In the Matter of	)	
TEXAS UTILITIES ELECTRIC	)	Docket Nos. 50-445 <sup>OL</sup> and
COMPANY, ET AL.	)	50-446
(Comanche Peak Steam Electric	)	(Application for
Station, Units 1 and 2)	)	Operating Licenses)

APPLICANTS' THIRD PARTIAL RESPONSE TO CASE'S  
FIFTH SET OF INTERROGATORIES RE: CREDIBILITY

TABLE 1

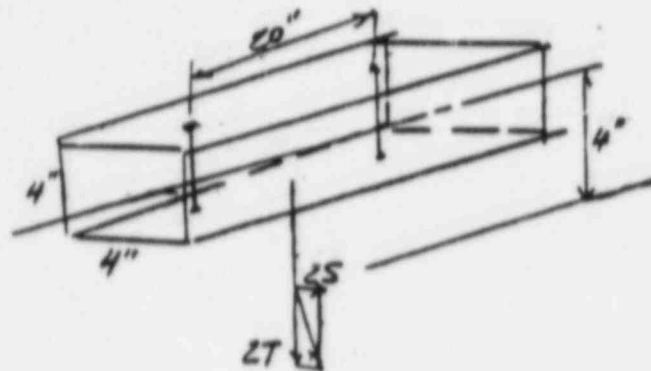
Question 20.f.: The impact of original modelling of the torsional resistance of the assembly is most pronounced for configurations where shear and/or direct torsion are large or dominant. Supports which are primarily loaded in tension, particularly if close to allowables, would have small or negligible shear contribution.

This is best illustrated by the following example which utilizes the method of analyses used in original design and then compares these results with what one would have concluded using the method described in the Affidavit. Consider, for instance, a 4 x 4 x 3/8 tube steel which is loaded as shown in the sketch, and that the bolts are subjected primarily to tension. Assume that the bolt material is A36 and that the bolt is 1-1/2" in

diameter. The tension in the bolt is the external tension load plus the incremental tension resulting from coupling out any torsion or bending resulting from shear. By the initial design method (see Attachment D to the Affidavit) the incremental tension value was derived by assuming that the torsion or bolt bending would be reacted by a couple acting through an arm length equal to the distance from the bolt centerline to the centroid of the concrete compression block assumed to extend from the neutral axis to the edge of the washer. By the simplest revised evaluation method, the arm length is reduced to the distance from the bolt centerline to the tangent point of tube steel and washer. More accurately, the torsion and shear are resolved in both increased tension (but lower than computed by the simplest revised evaluation method) and a bending moment carried by the bolt. We shall refer to the original method of design as method 1, the second method which is the same as the original method but with the use of the actual arm length as method 2, and finally to the most precise method as method 3. Table 1 below illustrates why shear loads would have to be small in order for supports which are primarily loaded in tension and are close to allowable values to be acceptable by the original method of design (method 2). This table takes the example tube steel and shows how tension and shear contributions to interaction ratios close to allowables vary as a function of externally applied tension and shear load ratios.

Table 2 shows how the interaction ratio would change for those cases of high tension and high interaction ratios when method 2 is applied. It also shows, by contrast, how the interaction ratio would change for those supports which are primarily loaded in torsion/shear, i.e., those examined by Applicants in the Affidavit.

It is evident that the higher the shear/torsion the higher is the percentage change in interaction ratio, and the larger is the possible impact of underestimating the torsional resistance of the Richmond. By the more accurate method of considering that a
